Minutes of the meeting of Pre-Bid for 10 Nos. of Wind Profiler systems (WPS) under 'Mission Mausam' held on 21.08.2025 at 1100 hours IST

The India Meteorological Department has invited bids vide Tender No. CPU/53/0825/1555 dated: 07.08.2025 for the procurement of 10 Nos. of Wind Profiler systems (WPS) under Mission Mausam through the CPP portal of the Government of India and the IMD website. Secretary, MoES has constituted the following Committee pertaining to the Pre-bid and technical and financial evaluation vide File No. DGM-HQ-24010/29/2024-UAID (Comp. No. 39141)vide Note#230 dated 18.08.2025 comprising the following members:

Tentative Drawing for the proposed Wind Profiler System

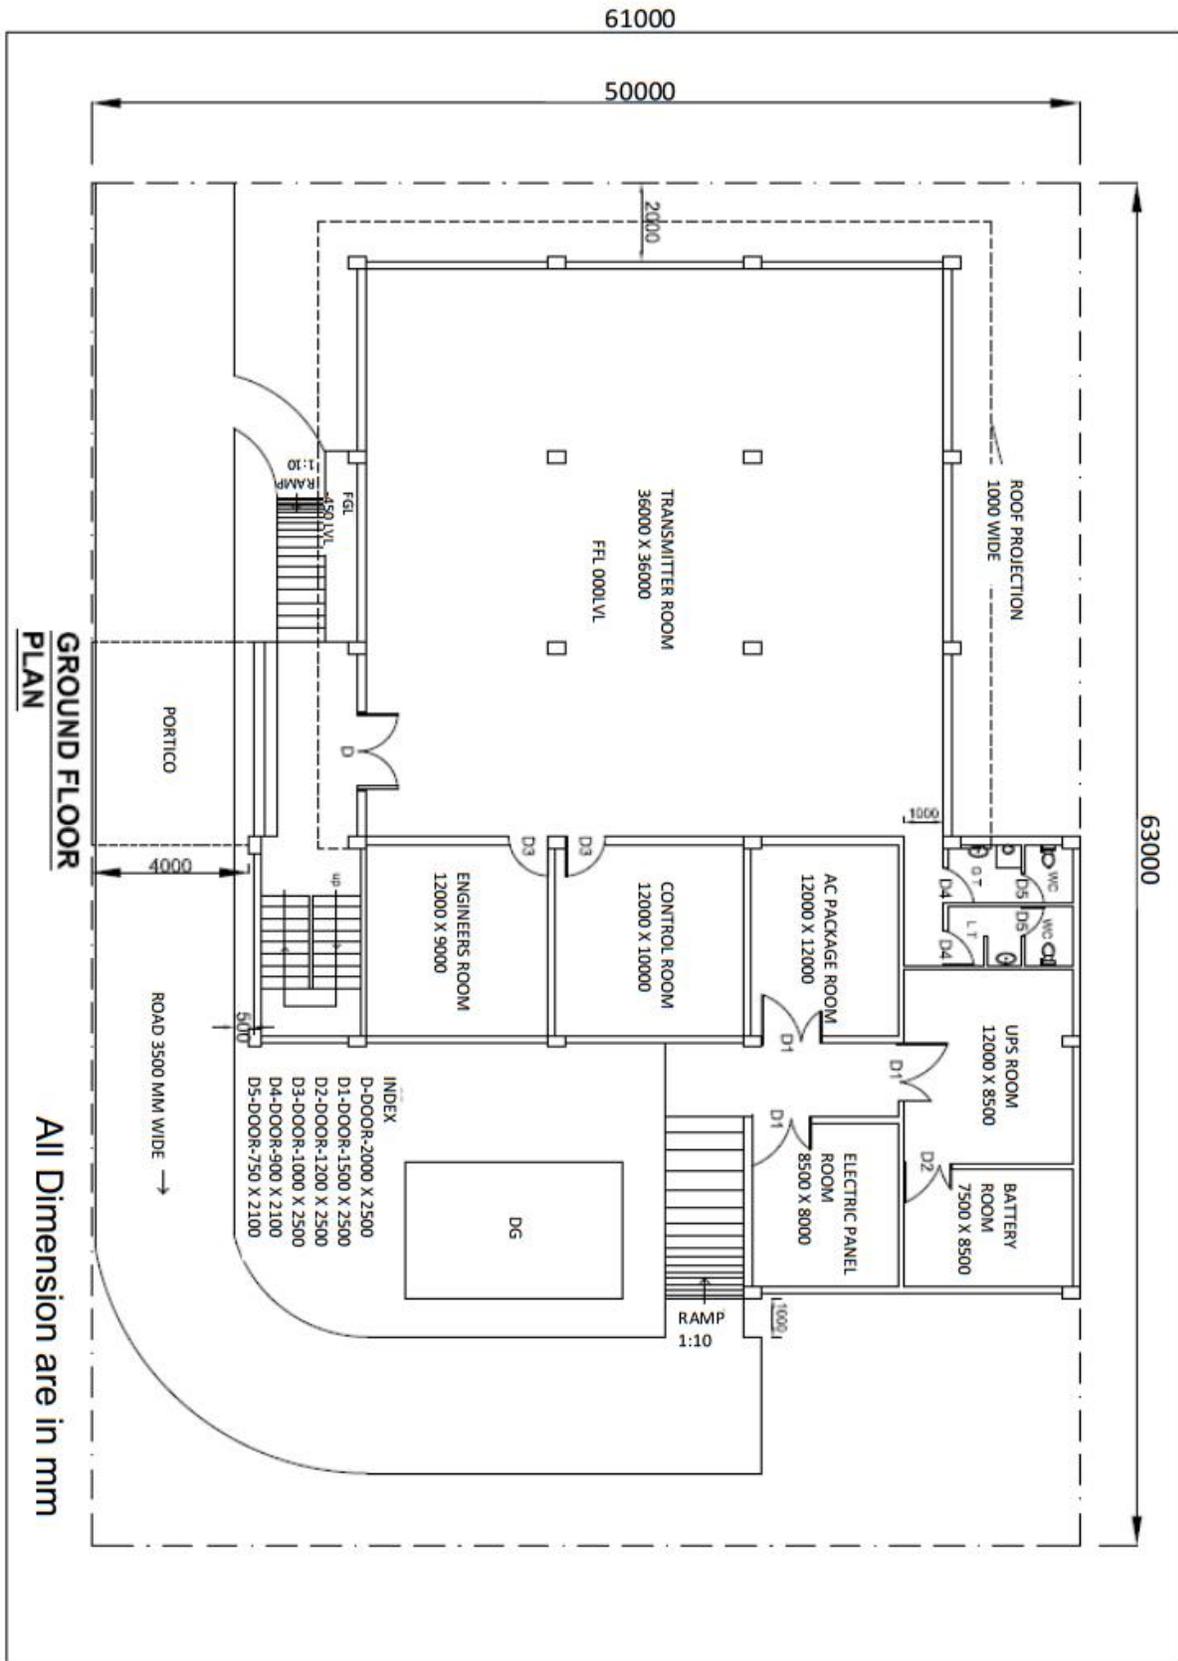
| 151/242 | 1 5 CIVIL, AC, ELECTRICAL | 1 5 1 The Manufacturer shall take into consideration that the system is required to be installed on site on a building top with nominal height of around 10 meter upon which antenna array shall be installed and TR Modules will be | It is required to build antenna subsystem on roof top of a building, which is around 4.5m ceiling height. If it is required to be raised to 10m, building cost will be very high without getting any advantage. IMD may kindly suggest. | <p>a) The Manufacturer shall take into consideration that the system is required to be installed on site on a building top with nominal height (A minimum of 3.00 meter clearance shall be available from ground to bottom of TRMS after fixing in the ceiling) upon which antenna array shall be installed and TR modules will be hanging, with proper mechanical assembly, just beneath the</p> |

| | | <p>hanging, with proper mechanical assembly, just beneath the roof top.</p> | | <p>roof top. b) Minimum one and a half meters around free space should be available around the antenna array for the free movement and accessibility to the antenna. Vendor shall consider the calibration of antenna during installation in the array before finalizing the distance between parapet wall & array boundary. c) The tentative building structure for the proposed WPS system is attached as Annexure-1. However, finalization for the civil, electrical and AC requirement will be done during DDR with the successful bidder. Rest of the requirements as depicted in sections 1.5.1 to 1.5.4 and 2.1.2 of Section VII: Technical Specifications and Quality Assurance should be strictly meet as per tender requirement.</p> |
